RE: Grandview Terrace

We sincerely thank you for the opportunity to present more specific written comments following our brief oral comments at the conclusion of the previous Type 3 review hearing of the proposed Grandview Terrace apartment development. Our comments will primarily address the traffic and personal safety issues that will be created if this project for 230 units is approved as presented and designed.

RE: PA-T3-2022-00004, 1511 Highway 99 North

Exhibit A

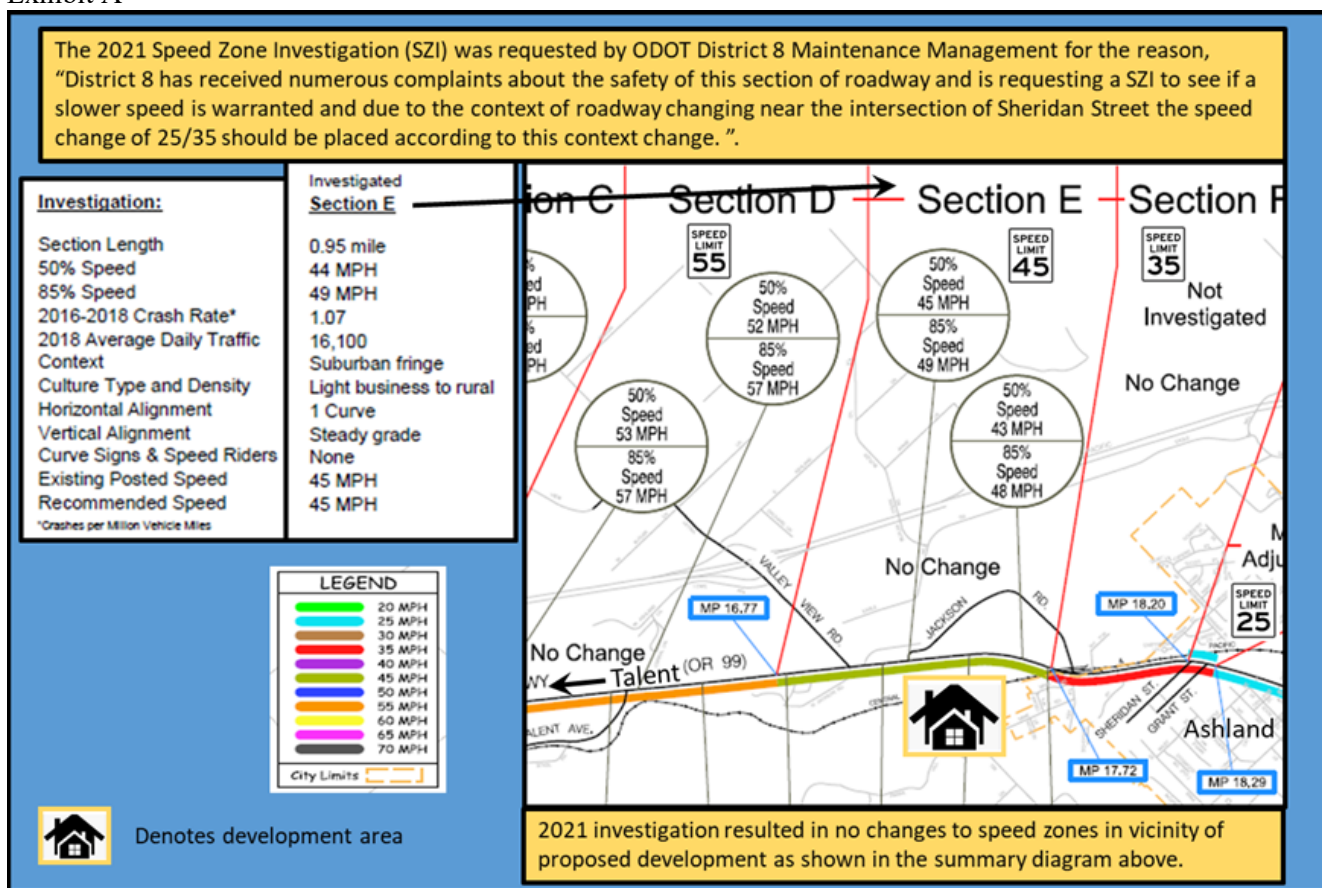
ODOT Region 3 Traffic staff conducted a Speed Zone Investigation (the “Investigation”) along Rogue Valley Highway (OR99) which was completed in June 2021 to determine whether a lower posted speed limit is warranted. The study examined speeds along OR99 from approximately Hartley Rd in the City of Talent to Grant Street in the City of Ashland.

The study methodology included evaluation of the roadway context, intersecting streets, horizontal and vertical alignment of the Highway, existing traffic data, and speed data collected on-site during the Investigation. The Subject Property is located within an area of the Investigation identified as “Section E” which extends from approximately Valley View Road to the trestle north of Jackson Road. The investigation found a 50th percentile speed of 44mph, and an 85th percentile speed of 49mph.

The speed of existing traffic is one of the factors considered when evaluating whether a speed reduction is appropriate. The rationale is that simply changing the posted number generally doesn’t make the facility safer as a stand-alone measure. This can lead to large speed differentials with the possibility of increasing aggressive and dangerous driving maneuvers. As the physical context of the roadway changes, such as narrowing the travel lanes, installation of frontage improvements, and traffic calming measures a natural decrease in vehicle speeds is expected. Evaluation criteria is weighted differently within urbanized areas in city limits versus rural unincorporated areas. ODOT recommends the City request a new speed zone investigation after development and installation of frontage improvements so posted speeds can be established based on the new driving culture created by the existence and roadside improvements associated with this development proposal.

Exhibit A

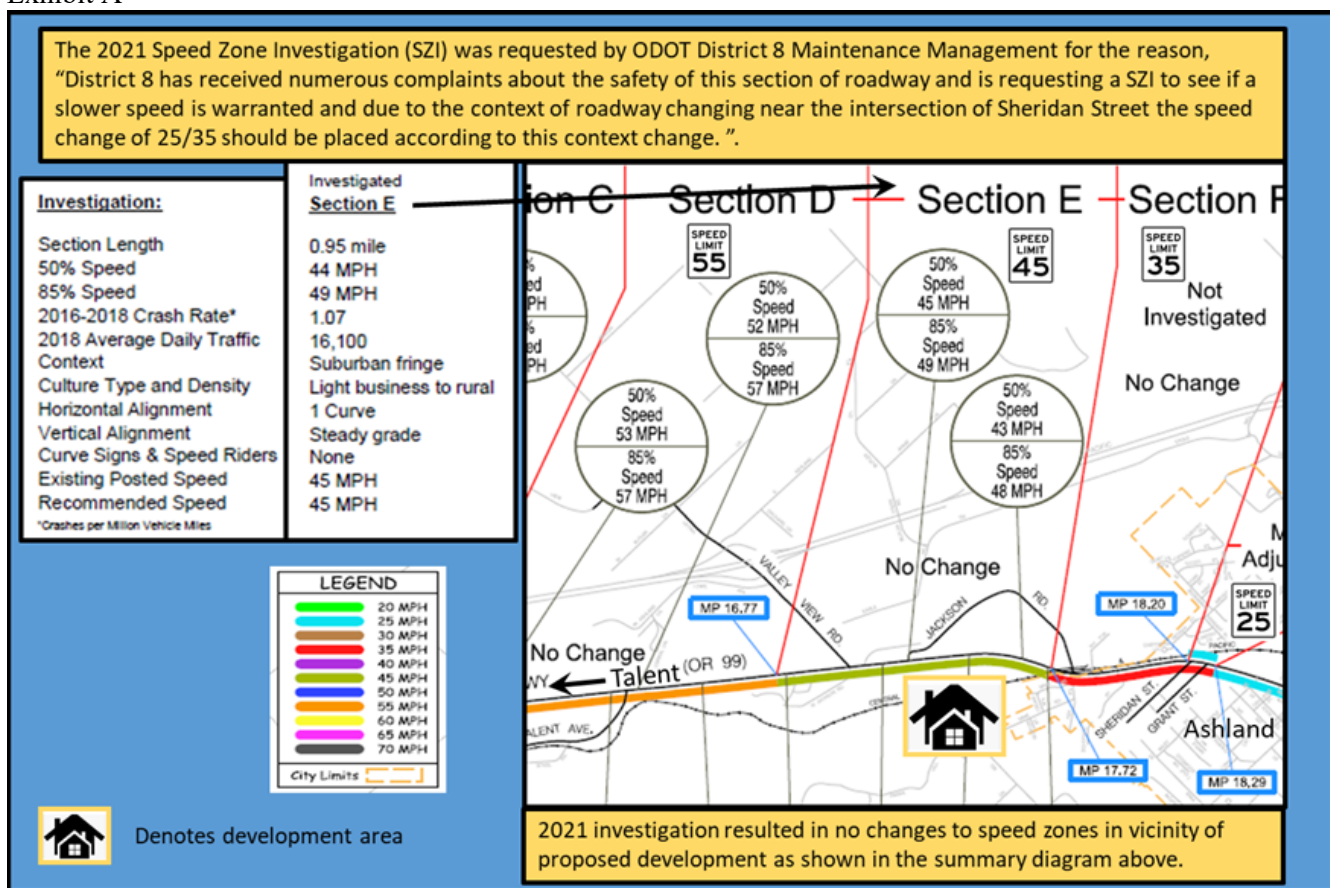
ODOT Region 3 Traffic staff conducted a Speed Zone Investigation (the “Investigation”) along Rogue Valley Highway (OR99) which was completed in June 2021 to determine whether a lower posted speed limit is warranted. The study examined speeds along OR99 from approximately Hartley Rd in the City of Talent to Grant Street in the City of Ashland.

The study methodology included evaluation of the roadway context, intersecting streets, horizontal and vertical alignment of the Highway, existing traffic data, and speed data collected on-site during the Investigation. The Subject Property is located within an area of the Investigation identified as “Section E” which extends from approximately Valley View Road to the trestle north of Jackson Road. The investigation found a 50th percentile speed of 44mph, and an 85th percentile speed of 49mph.

The speed of existing traffic is one of the factors considered when evaluating whether a speed reduction is appropriate. The rationale is that simply changing the posted number generally doesn’t make the facility safer as a stand-alone measure. This can lead to large speed differentials with the possibility of increasing aggressive and dangerous driving maneuvers. As the physical context of the roadway changes, such as narrowing the travel lanes, installation of frontage improvements, and traffic calming measures a natural decrease in vehicle speeds is expected. Evaluation criteria is weighted differently within urbanized areas in city limits versus rural unincorporated areas. ODOT recommends the City request a new speed zone investigation after development and installation of frontage improvements so posted speeds can be established based on the new driving culture created by the existence and roadside improvements associated with this development proposal.
